Re: REQUEST FOR ADDITIONAL INFORMATION UNIVERSITY OF FLORIDA TRAINING  
REACTOR DOCKET NO. 50-83

**REQUEST FOR ADDITIONAL INFORMATION  
UNIVERSITY OF FLORIDA TRAINING REACTOR  
DOCKET NO. 50-83**

Responses to  
REQUEST FOR ADDITIONAL INFORMATION  
UNIVERSITY OF FLORIDA TRAINING REACTOR  
DOCKET NO. 50-83

Figure 2 schematic of UFTR secondary coolant system used for determination of heat exchanger inlet/outlet pressures.

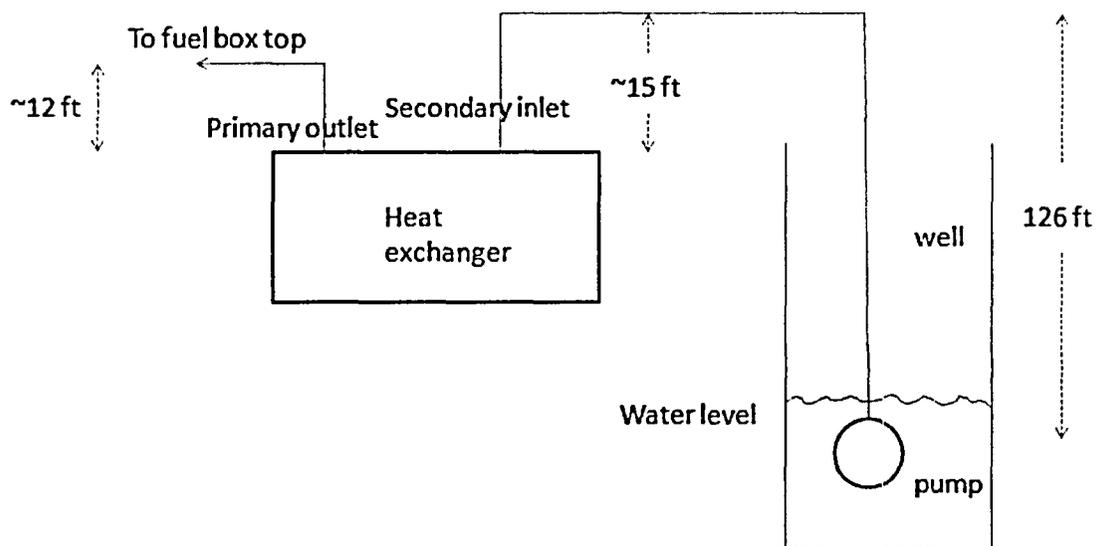
*Question 1: Your letter dated April 7, 2008, states that the normal operating pressure for the secondary side is not monitored, but that secondary flow rate is about 4 times higher than the primary flow rate so the dynamic pressure of the secondary system is expected to be higher than the primary system pressure. Therefore, if a significant leak is developed on the primary/secondary boundary, the resistivity of the primary water is expected to change, which is constantly monitored and controlled. The technical specifications (TSs) limits on primary flow rate are greater than 36 gpm or 41 gpm depending on fuel coolant channel spacing tolerance, and the TSs limits on secondary flow rate are greater than 60 gpm when using a well system and 8 gpm when using city water.*

*Is the assumption that a significant leak would be detected in the primary water resistivity valid if the reactor is operating at the TS limit of 36 gpm or 41 gpm primary flow rate (or normal primary flow rate if it is in excess of the allowed TS limit) and 60 gpm or 8 gpm secondary flow rate? In your response, address how the primary and secondary pressures are affected by the flow characteristics in the heat exchanger.*

The heat exchanger shell-side and tube-side inlet/outlet pressures are not monitored in UFTR. However, we can estimate the pressures based on the piping layout and pump characteristics. Figure 5-5 in UFTR SAR shows the schematic of UFR secondary coolant system. The figure is also attached in this document (Appendix A). A simplified version of Figure 5-5 in SAR is used here to estimate the primary outlet and secondary inlet pressures as shown in Figure 2

The well pump, model *150H10* is manufactured by Goulds Pumps, ITT Industry. The specifications of the pump are given in Appendix B. According to the data given in the Appendix, the pump at 10 hp, for 200 gpm, has a dynamic head of 163 ft. In Figure 3,

the height difference between the pump and heat exchanger is ~111 ft (126 ft minus 15 ft). Assuming no significant pressure loss in the pipes, the secondary inlet pressure is about 50 ft (163 ft minus 111 ft) water above the atmosphere pressure. While on the primary side, the height from the heat exchanger to the top of fuel box (where the pressure is atmosphere) is ~12 ft. The primary outlet pressure is about 12 ft water above the atmosphere pressure. Considering 1 psi is equal to 2.306 ft water, then the inlet pressure for the secondary is ~36.4 psi, and the outlet pressure for the primary is ~19.9 psi. Considering the expected pressure drop in the heat exchanger give in Table 2, the secondary outlet pressure is ~34.2 psi, which is ~72% higher than the primary outlet pressure. This difference increases as the secondary flow rate decreases, e.g., at 100 gpm with a dynamic head of 238 ft, the pressure difference is ~251%. This means that there is always a negative pressure which prevents any leak from the primary loop to the secondary loop.

Figure 1 - Comparison of the activity release for different operation time as a function of sodium concentration (100 kW, 1 liter/hr, 60 gpm)

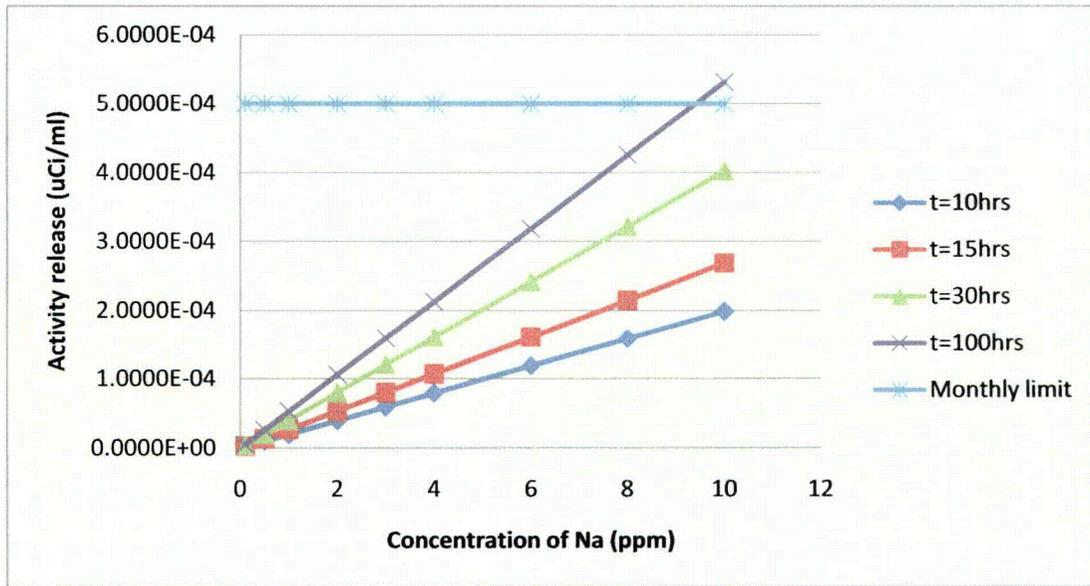
**Question 2a:** *What is the basis for the ‘assumptions of 1 ppm sodium in the primary coolant, activation for 10 hours, and 1 liter/hour leak rate for 1 hour?’*

Here, in order to examine the effect of higher Na concentration and longer operation times, we evaluate the activity release for concentrations in a range of 1-10 ppm for operation hours of 10 to 100 hrs. Figure 1 compares the activity release for different hours of operation as a function of Na concentration in the primary coolant. Note that these calculations are based on 1 liter/hr leakage rate, and 60 gpm secondary flow rate.

Above figure indicates that the activity is less than the monthly limit if sodium concentration is less 9 ppm even at an unrealistic case of 100 hrs of operation. Only, for cases with concentrations between 9 ppm and 10 ppm the concentration exceeds the limit for the 100 hrs operation case. Further, this diagram indicates at a more realistic value of Na concentration of 1 ppm and operation time of 10 hrs, the activity release is less than the limit by a factor of ~25.

Figure 3 - Comparison of the activity release for different sodium concentrations as a function of secondary flow rate for 1 liter/hr leakage (operation time of 10 hrs, 100 kW).

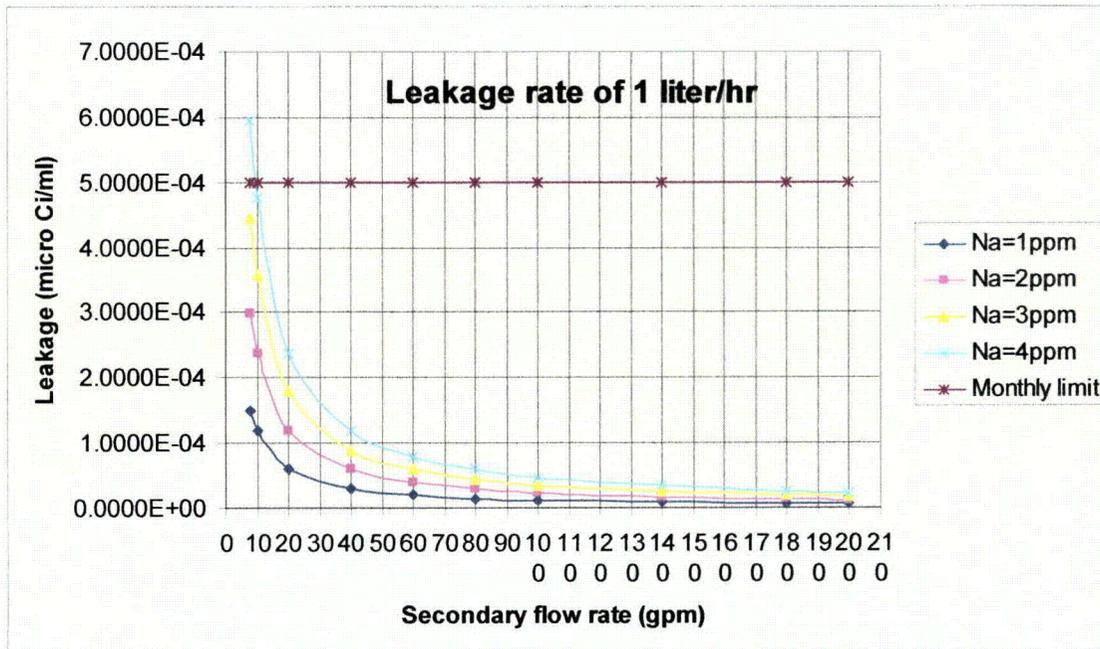
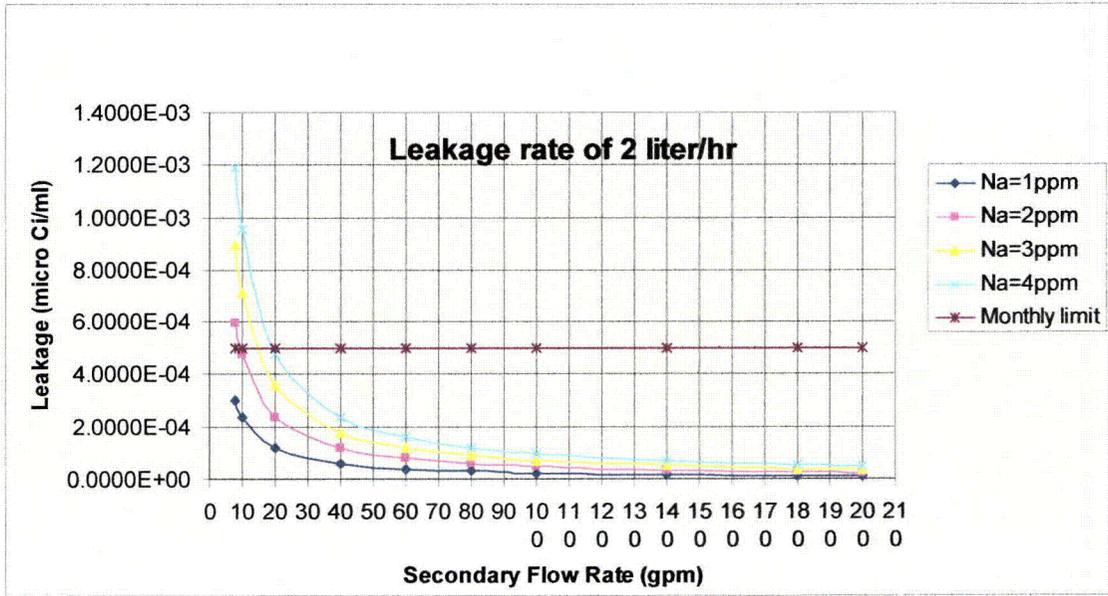
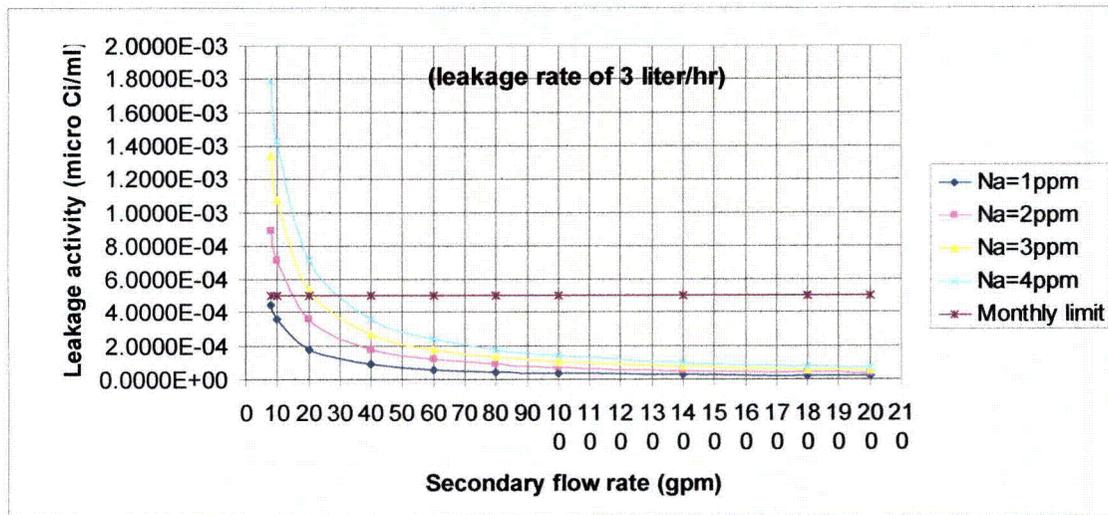
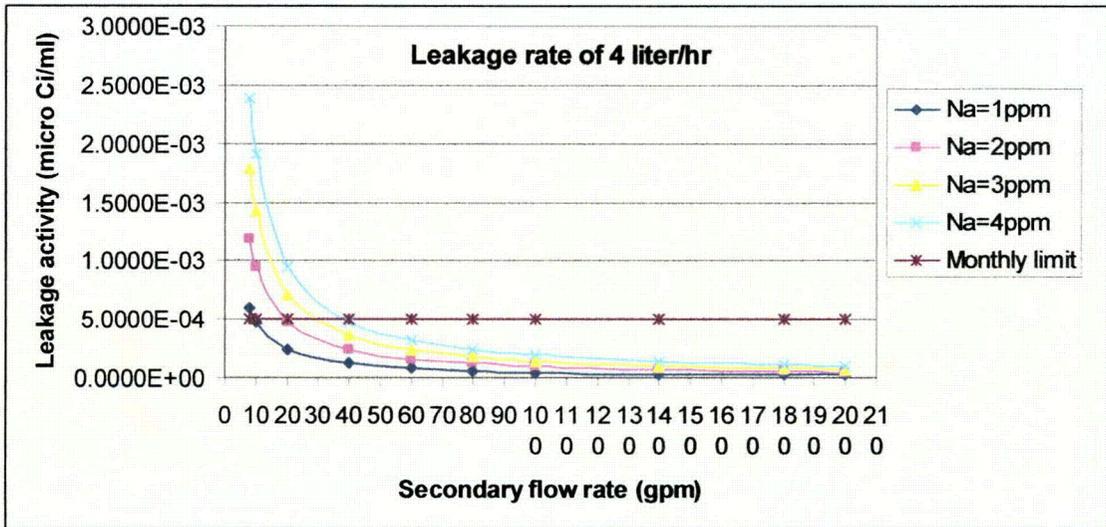
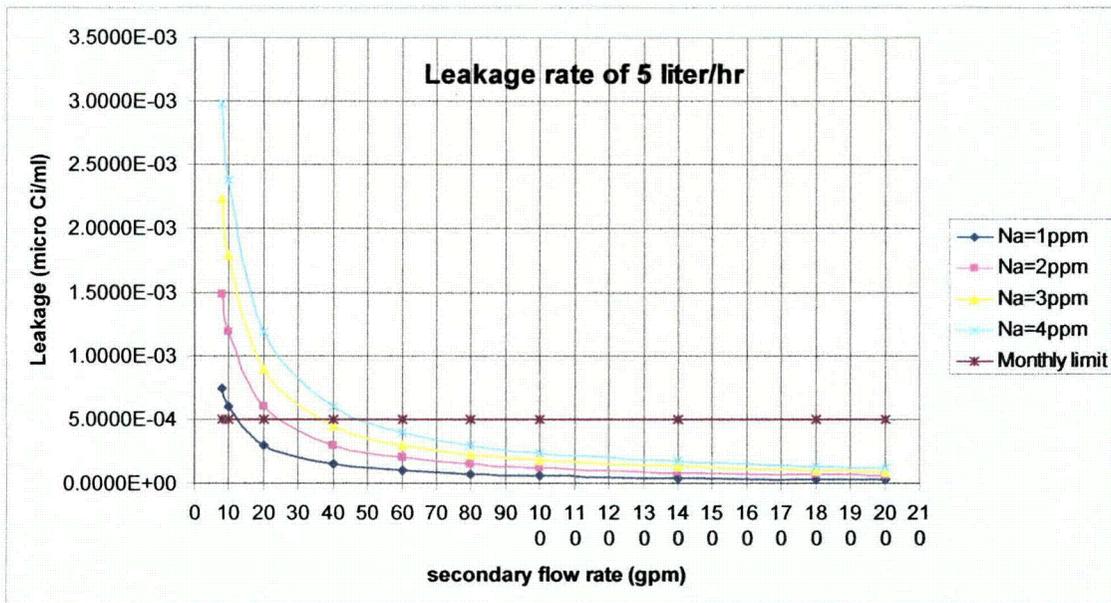
*Question 2c. As discussed previously, the TS limit on secondary flow rate is 60 gpm when using well water and 8 gpm using city water. Therefore, provide an estimated effluent concentration assuming the allowed TS limits for secondary flow.*

Above figure indicates even if the secondary flow is as low as 8 gpm, the leakage activity is less than the limit for Na concentrations of up to 3 ppm. If the secondary flow rate is between 100 gpm to 200 gpm, where the latter is the nominal value, for a more realistic Na concentration of 1 ppm, the leakage activity varies in the range of  $1.2 \times 10^{-5}$  to  $6 \times 10^{-5}$  which is significantly smaller than the limit by a factor of  $\sim 40$  to  $\sim 100$ .

Figs. 4 to 7 show the leakage activity as a function of secondary flow rate for different Na concentrations for leakage rates of 2, 3, 4, and 5 liter/hr, respectively.

Above figure shows that as long as secondary flow rate is more than 60 gpm even for 5 liter/hr leakage rate, for a realistic Na concentration of 1 ppm, and 10 hrs of operation time at 100 kW, leakage activity is significantly less than the limit by a factor of ~5.

In conclusion, above analysis demonstrates that considering highly conservative parameters including operation time of 10 hrs, total flux level of  $2 \times 10^{12}$ , leakage rate of 5 liter/hr, power of 100 kW, and Na concentration of 1 ppm, leakage activity will remain significantly below (by a factor of 5) the monthly limit if the secondary flow rate is above 60 gpm.

Since the city water is not meant to be used for normal operation, and reactor does not need cooling in case of loss of coolant, we intend to modify the Technical Specification by removing the use of city water and increasing the secondary flow trip setpoint to 100 gpm. For this situation even for the leakage rate of 5 liter/hr, the activity leakage is less than the limit by a factor of 10.
